Change Proposal – BSCP40/02	CP No: 1260 Version No: 1.0 (mandatory by BSCCo)
Title (mandatory by originator) Meter Investigation Process where a Site is Capable of Exporting (microgeneration)	
Description of Problem/Issue (mandatory by originator) The purpose of this CP is to ensure that Suppliers are aware when an Import Meter is at risk of capturing Export energy (i.e. when microgeneration will be or has been installed on a site) and to create a process for checking (and if necessary, replacing) the Import metering. <u>There is no requirement to fit an Export Meter.</u> <u>Background - P213</u> P213 ‘Facilitating Microgeneration’¹ ‘Optional Single MPAN’ was raised by E.ON on 27 April 2007. The P213 Modification Group noted in their Assessment Report that a review of the current processes might be useful to understand if there are any Settlement process issues that are preventing a greater take up of the microgeneration solution introduced by P081 ‘Removal of the requirement for Half Hourly Metering for Third Party Generators at Domestic Premises’. The Panel requested that the Supplier Volume Allocation Group (SVG) raise a CP issue to consider whether any changes could be made to

Figure 1(above): illustrates the model as proposed by CP1260.

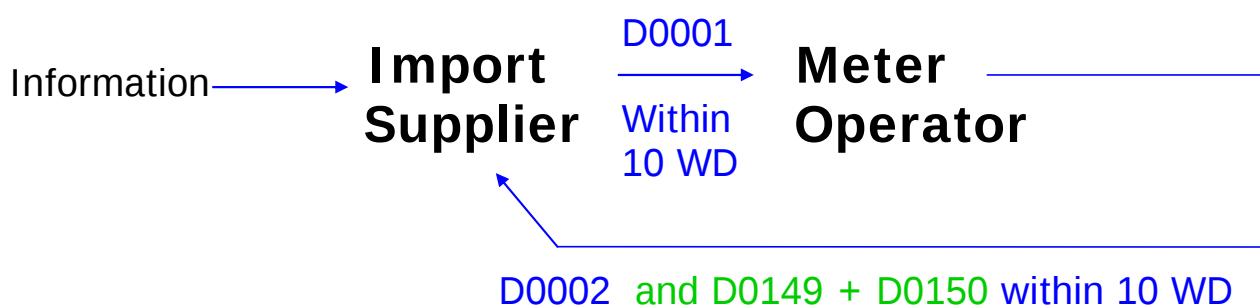
This solution has been developed with the aim of documenting a Meter investigation process where microgeneration **has been or will be** installed at a site.

It consists of the following:

- (a) On becoming aware that microgeneration equipment has been or will be installed, the Import Supplier sends a D0001 'Request Metering System Investigation' flow to the Meter Operator to investigate/confirm whether the Import Meter requires a backstop or replacing within 10 Working Days (WD). The D0001 will also provide the MOA with details of the action required should the Meter be unable to measure Import energy separately to Export energy (e.g. install a backstop or replace the Meter).

- (b) The Meter Operator subsequently investigates whether the Meter is capable of accurately reading Import energy separately to any Export energy and where appropriate replaces the Meter. The Meter Operator responds to the Import Supplier within 10 WD with a D0002³ flow to confirm the results of the investigation. A D0149⁴ and D0150⁵ will also be sent at the same time if the Meter has been replaced.
